**ICC (ANSI A117) CONSENSUS COMMITTEE ON ACCESSIBLE
AND USABLE BUILDINGS AND FACILITIES**

**Second Ballot
Editorial draft report
2025-9-23**

FIGURE 611.7(C)
ROLL-IN SHOWERS FOR ASSISTED BATHING
OPTION 3

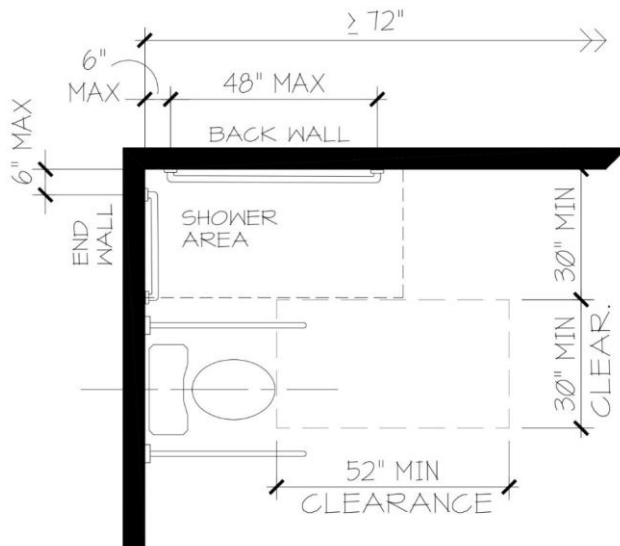
(Editorial to review minimum vs. maximum in figure)

Figure 908.2 DOOR AND ACCESS PANEL

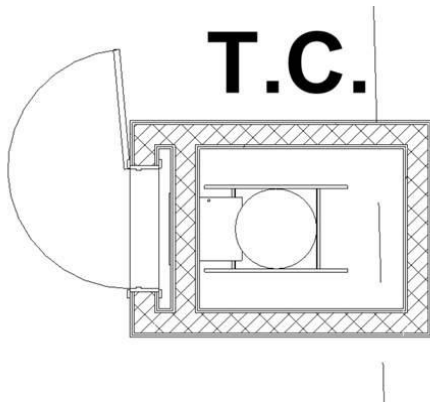
(Drawing should include maneuvering clearance at outside and indication of the hold open devices.)
